Product/Process Change Notice (PCN)

PCN_IndTPC_2828_ThicknessCarrierTape:

Product Affected: WE-TPC 2828 series

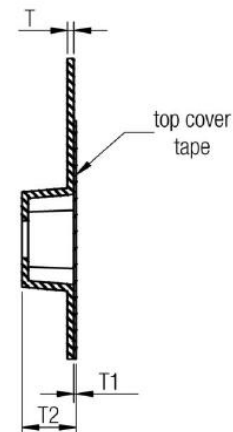
Due to the improvement of our product quality, the carrier tape thickness will change from 0.25 mm to 0.4 mm.

The new dimension of the tape thickness will be mentioned in the datasheet with the abbreviation of a "T".

In consequence of this change will be also affected the thickness of T2. Hence, T2 will change from 1,60 mm to 1,75mm.

BEFORE "T" = 0,25 mm.

AFTER "T" = 0,40 mm.

BEFORE "T2" = 1,60 mm.

AFTER "T2" = 1,75 mm.
